**SUBJECT:** NuScale Power, LLC Response to NRC Request for Additional Information No. 128 (eRAI No. 8966) on the NuScale Design Certification Application

## **Response to Request for Additional Information Docket No. 52-048**

**eRAI No.:** 8966

### **NRC Question No.: 03.08.04-3**

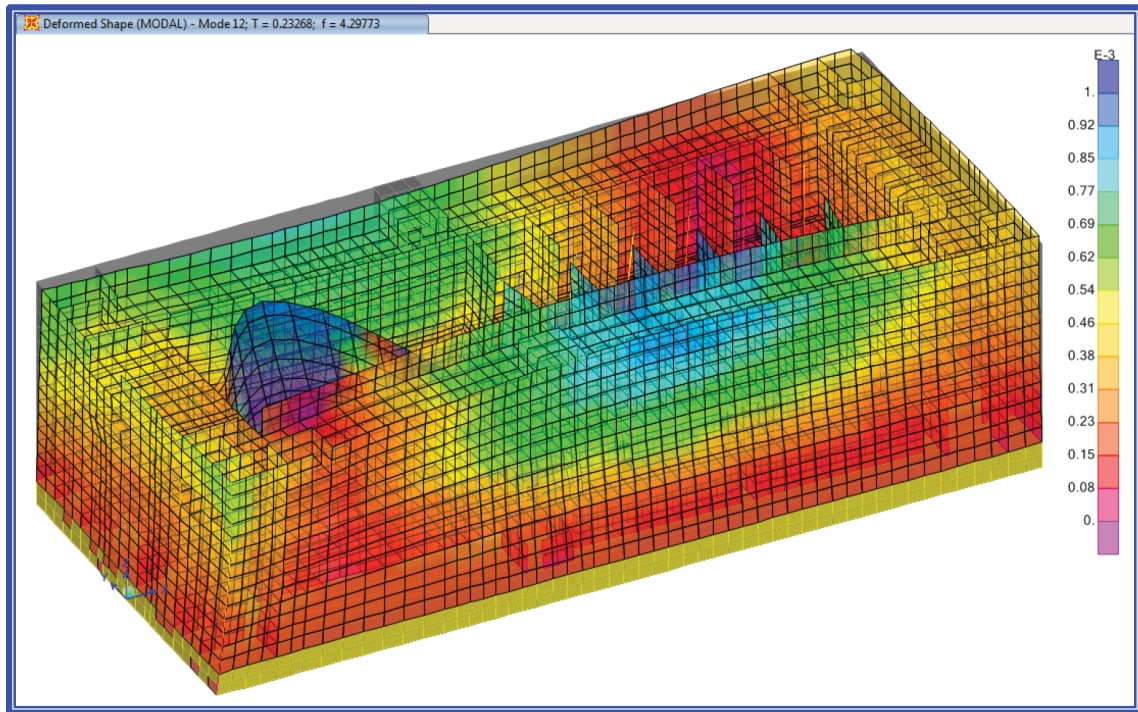
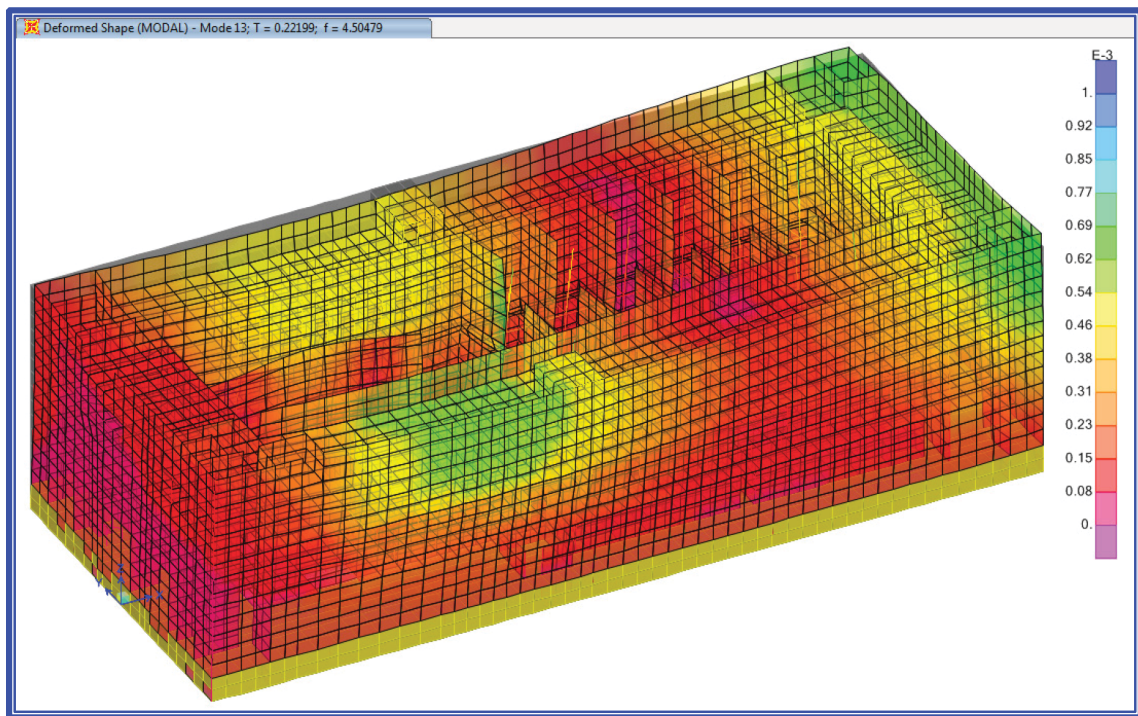
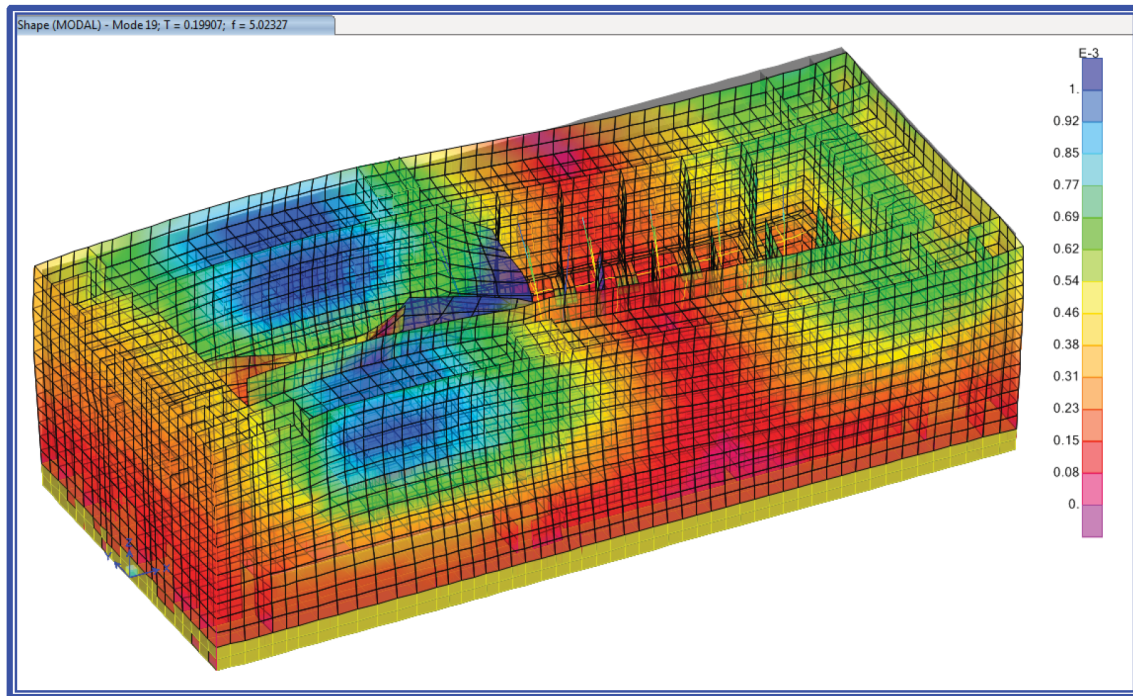
FSAR Figures in chapter 1, Section 3.8, and Appendix 3B show stiffener walls under the sloping portion of the roof. Clarify whether there are any stiffening members under the flat portion of the roof which has dimensions of approximately 82'-6" by 346'. If not, describe the process for determining that the flat roof plate without stiffening members is sufficiently stiff and strong to resist and transfer seismic demands from and to the two inclined roof plates. Provide maximum allowable roof deformation values for each of the North-South and East-West directions and the calculated corresponding roof deformation values. Provide the frequency, modal mass ratio, and mode shape, for the most significant torsional mode in the RXB.

Table 2 provides the frequencies and modal mass participation ratios for the most significant torsional modes in the RXB for the RXB cracked model.

Figures 1 through 3, below, show the related RXB cracked model mode shapes.
